Project: LFUCG PSOC

Change Order Proposal #14 -Grounding/Carpet Tile Changes

Proposal Request 21

Subject: Insulation

Subject: Lockers

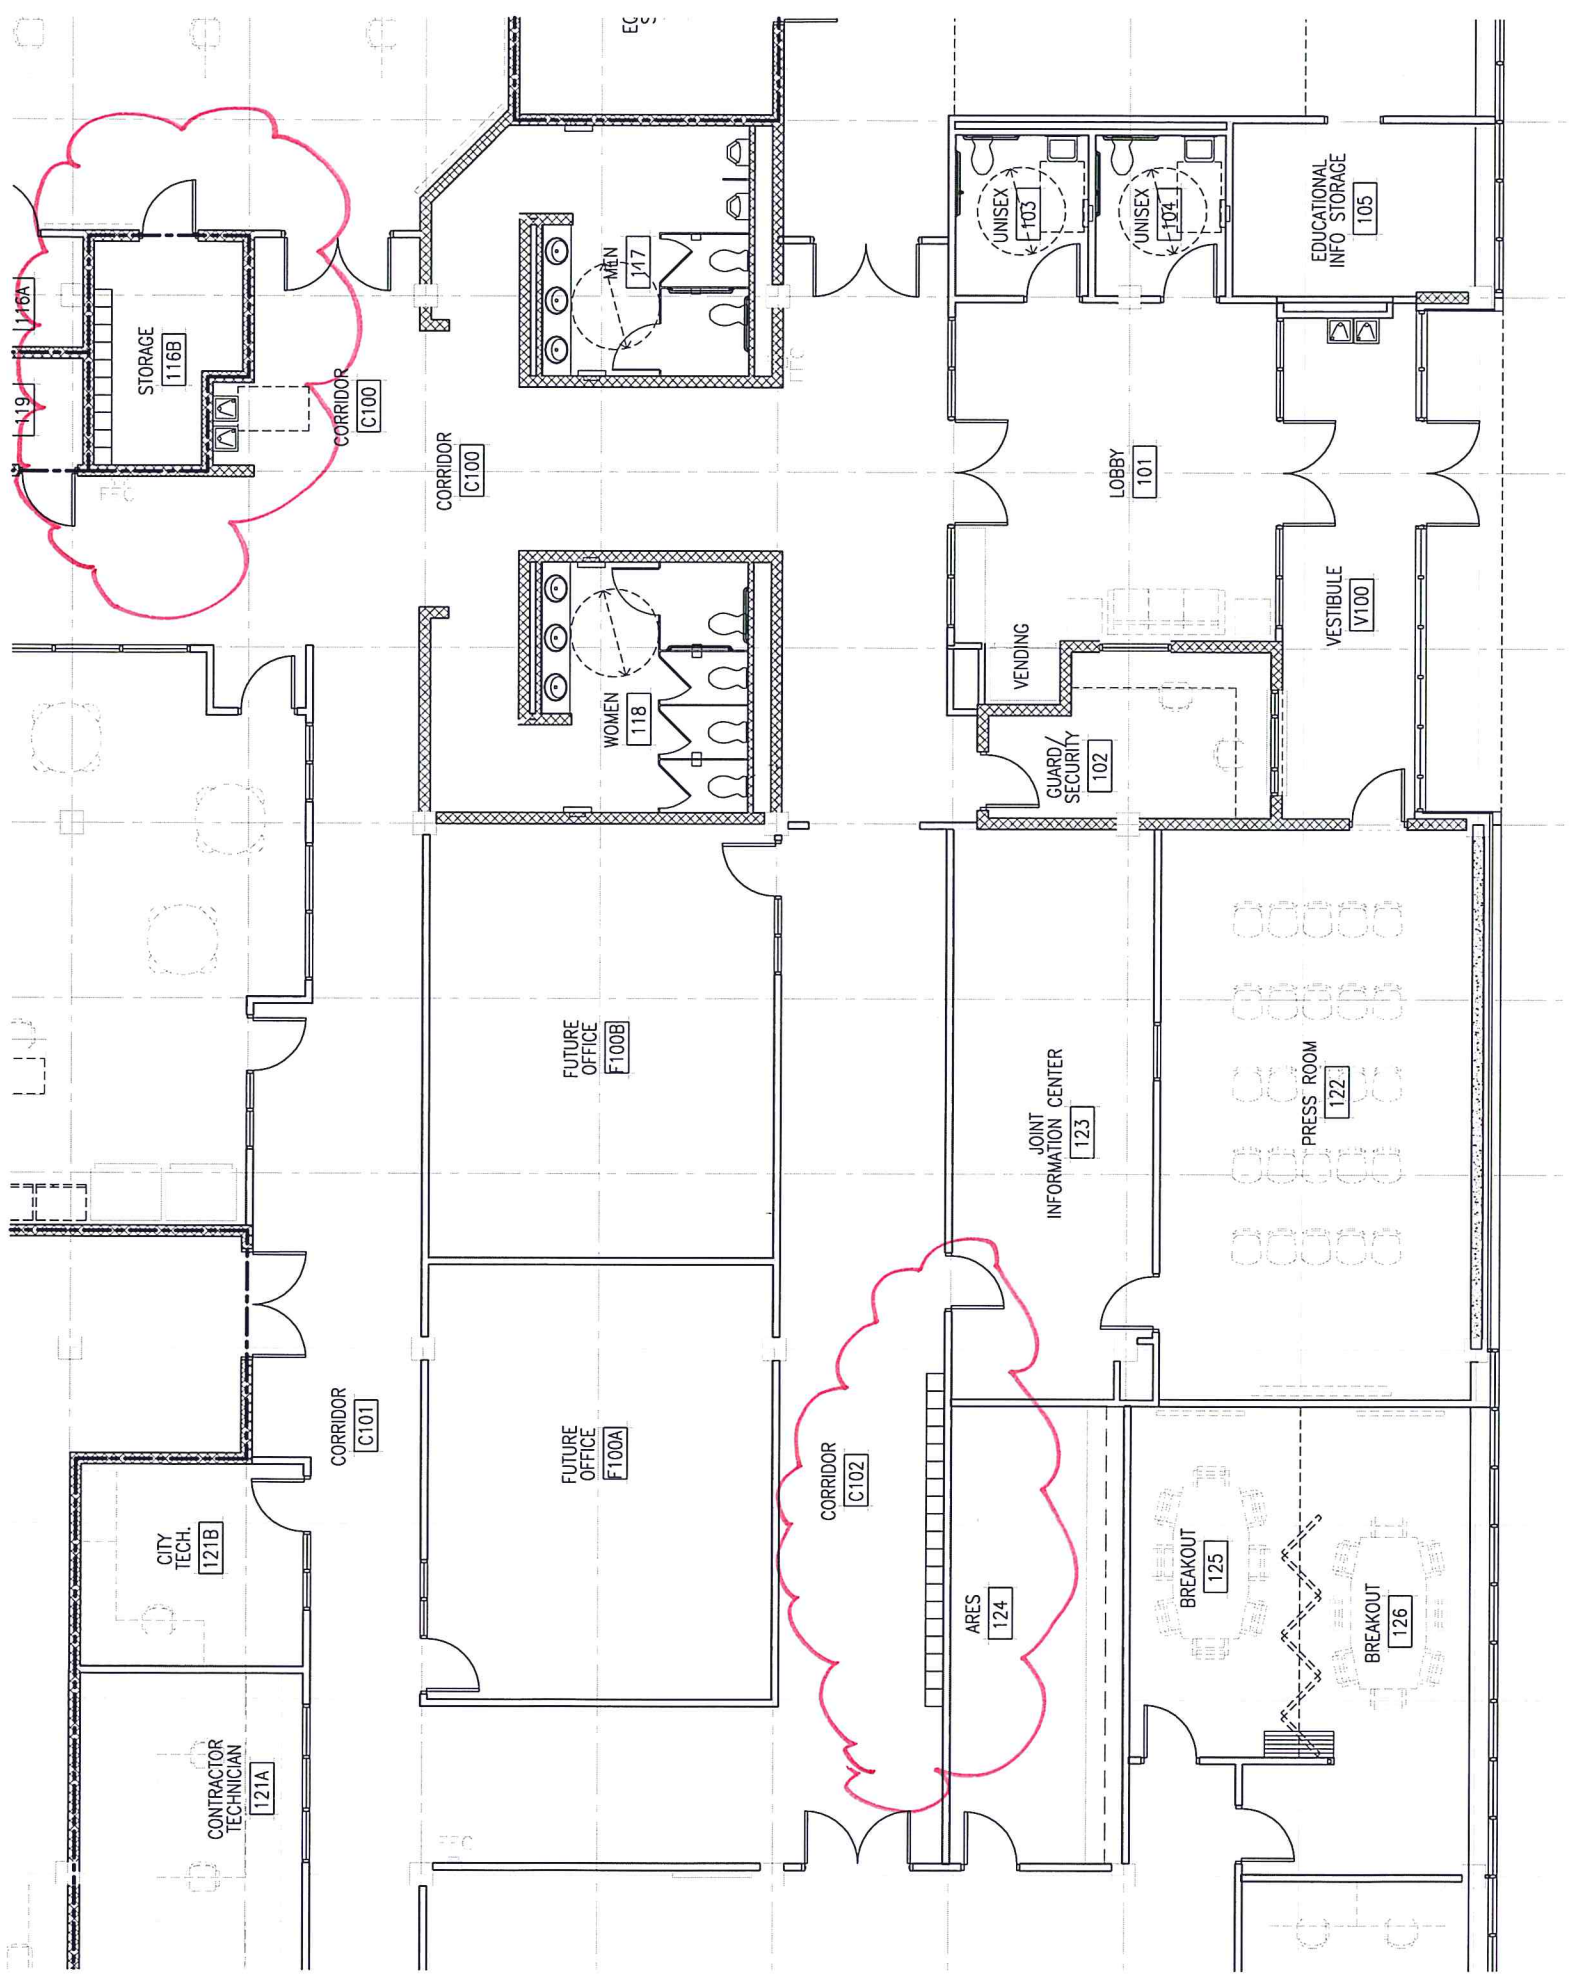
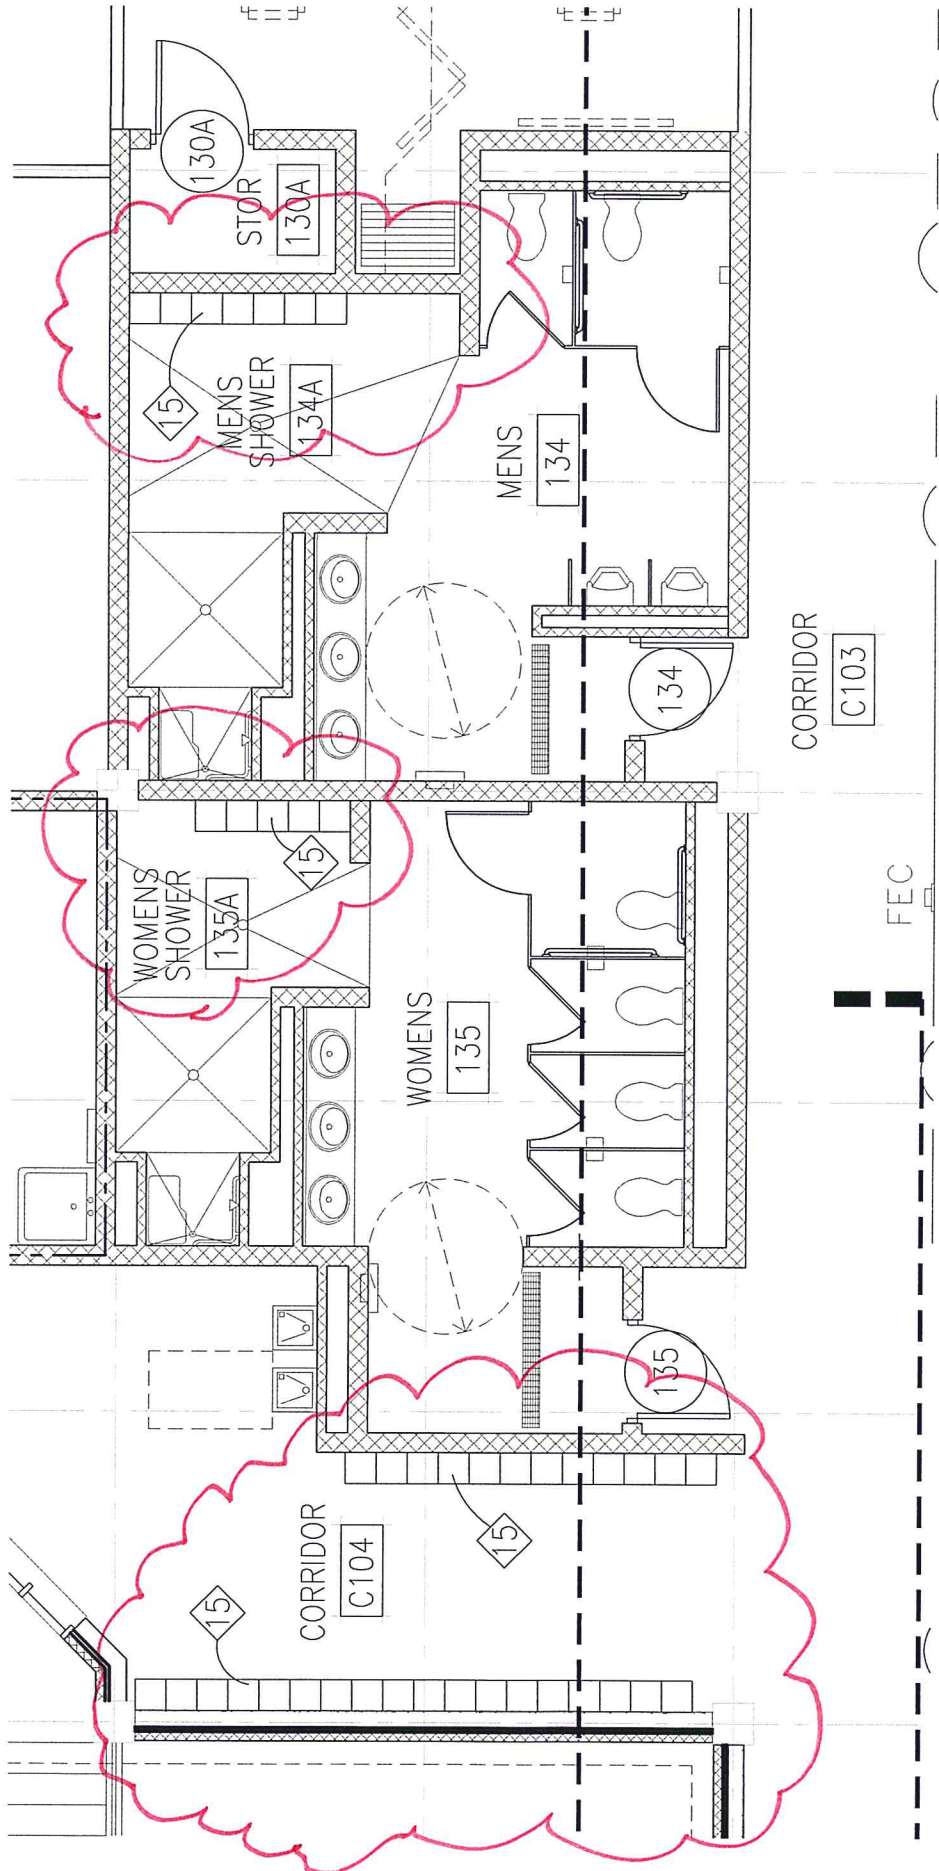
DELETE Lockers currently indicated on the floor plans (18"x18", single tier).

ADD new lockers in the spaces and arrangements indicated on attached sketches, as follows:

- Each locker shall be 12"x12" in plan, double tier unit.
- Other locker attributes shall be per spec section 105113 "Metal Lockers".
- Place as follows:
 - Storage 116B:
 - 10 lockers in plan (total of 20 lockers)
 - Corridor C102:
 - 19 lockers in plan (total of 38 lockers)
 - Corridor C104 - west wall:
 - 18 lockers in plan (total of 36 lockers)
 - Corridor C104 - east wall:
 - 12 lockers in plan (total of 24 lockers)
 - Men's Shower 134A:
 - 7 lockers in plan (total of 14 lockers)
 - Women's Shower 135A:
 - 5 lockers in plan (total of 10 lockers)
